Proposed Dublin Mountain Visitors Centre and all associated works  
in the:  
Townlands of Mountpelier, Killakee and Jamestown in South Dublin.

Submission to An Bord Pleanála  
**Ref No: JA0040**  
Proposed Dublin Mountain's Visitor Centre

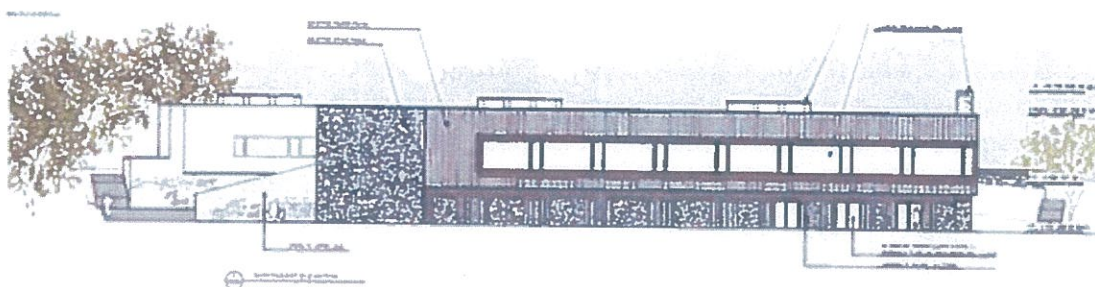
But I would argue that point and would refer to the elevation part of following Drawing No. 1639 / PA / 004 / A – This is an elevation of the Visitor Building. While the building itself is a relatively low elongated shape it is still a large building at a height of 8.5 metres high and length of nearly 48 metres long.

The building dominates the landscape and the gross external size I calculate as follows size is as follows

Lower floor visitor centre	396 sq. metres.
Upper floor visitor centre	469 sq. metres
Rear visitor interpretation building	342 sq. metres
A total of 1207sq. metres which is 12,992 square feet

This is a building of industrial scale proportions and I believe inappropriate in this location

We also refer to Drawing No ROD DRC0030 below which shows the landscape intersected with new pathways, trails, tarmac roads, grasscrete car parking, surface water and foul water drains, manholes and storage ponds.

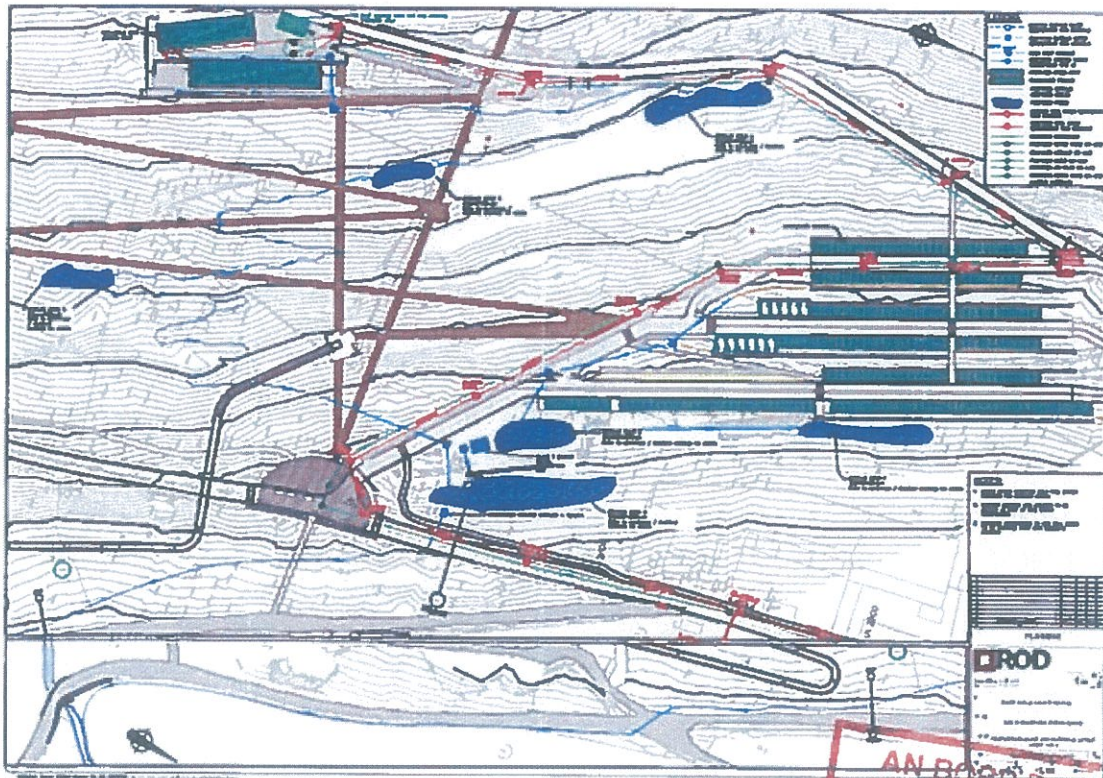
Is the below plan subject to  
"an appropriate scale of development".

Does it  
"protect and enhance the outstanding natural character of the Dublin Mountain area"?

Figure 11.11 Geophysical survey of the top of Montpelier Hill which was published in Jackman (2015)

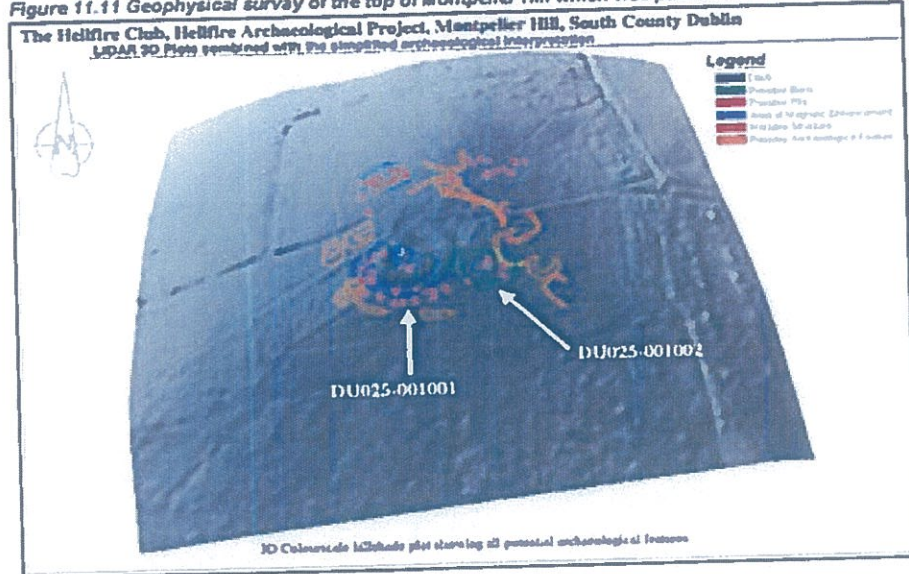
Even if this small area that was surveyed, there seems to be evidence of further archaeological features. Will these be disturbed during the building works at the Hellfire Club i.e. the removal of the stairs, the laying of gravel floor and the laying of cables and pathway up as per the proposed drawing below Drawing No 1639/PA/015/A? (The drawing below appears to show the circular ring cutting through some possible archaeological features)

Is there a case for a complete survey of the Montpelier Hill area?

**Figure 11.12** The 1950's pre plantation aerial photograph, as annotated by Jackman.

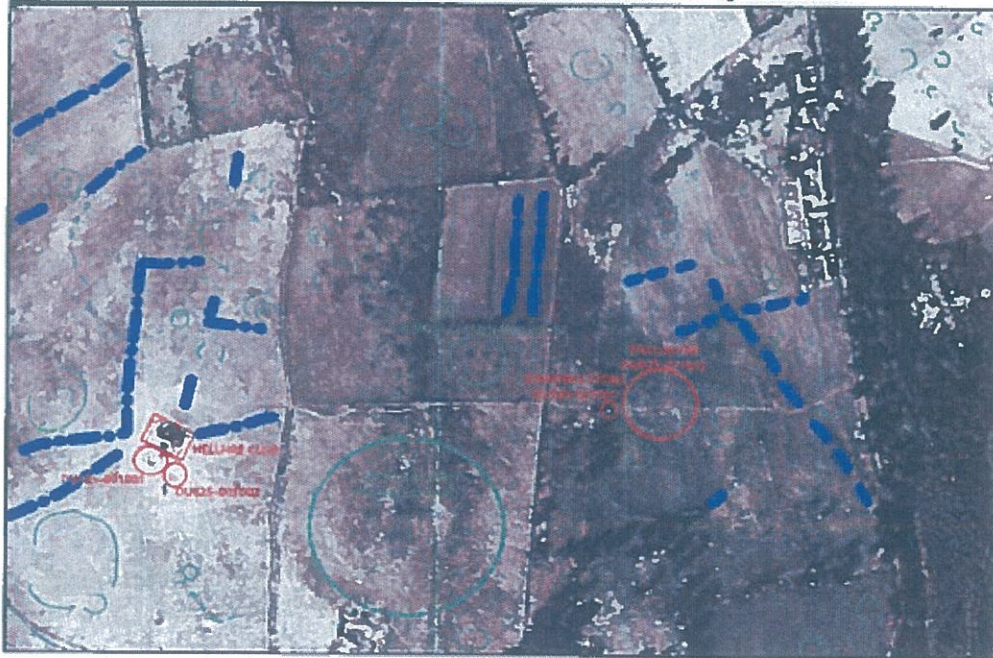
Furthermore, Neil Jackman, the archaeologist has annotated an old aerial photograph as above and there are other possible features all over the Montpelier hill area. He does state however that the features may be caused by shadows etc., but they are still worthy of some investigation. If the development proceeds they are likely to be damaged or lost perhaps forever
